**ADDENDUM NUMBER ONE**

**RFQ # 7447791**

**TITLE: ARRA – AUTOMATIC FIRE ALARM SYSTEM,  
CCRI**

**Subject:** Bid #7447791  
CCRI, Flanagan Campus, Lincoln, RI  
Automatic Fire Alarm System  
Addendum #1

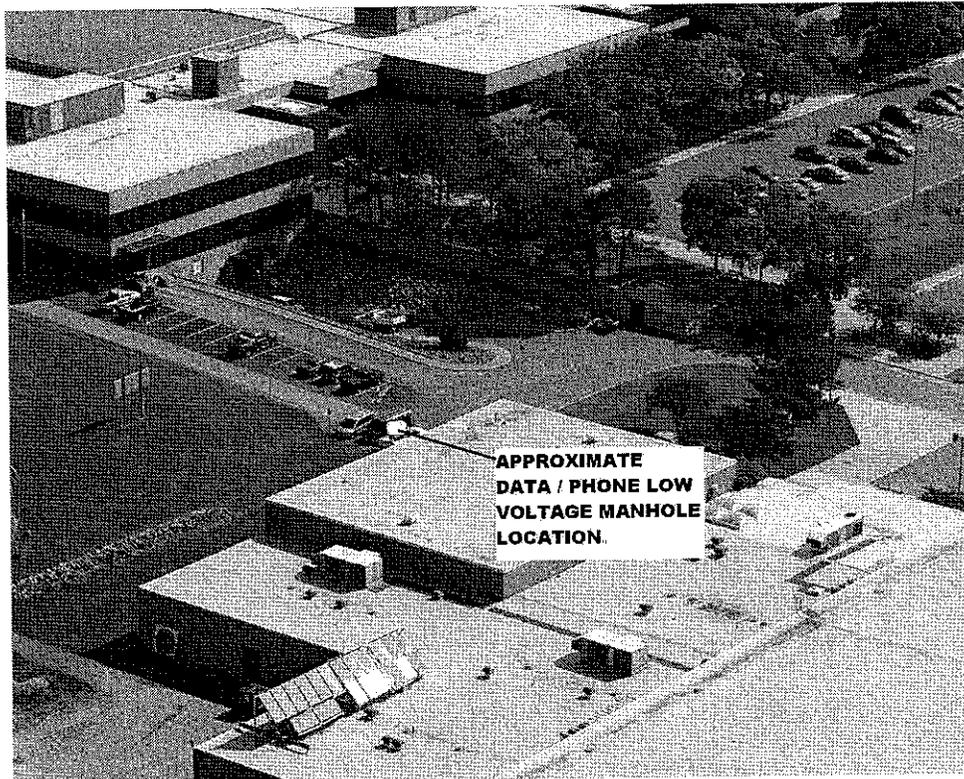
- I. As discussed during the Prebid meeting, the contractor will be responsible for providing a remote annunciator for the field house fire alarm system within the security office of the main building. CCRI has identified that raceway between buildings exists. Below is a photo indicating the approximate location of the manhole. The contractor is responsible for determining the capability and suitability of the existing raceway and manhole. If it is determined that the existing is not suitable, the contractor shall be responsible for the installation of a new raceway between buildings.
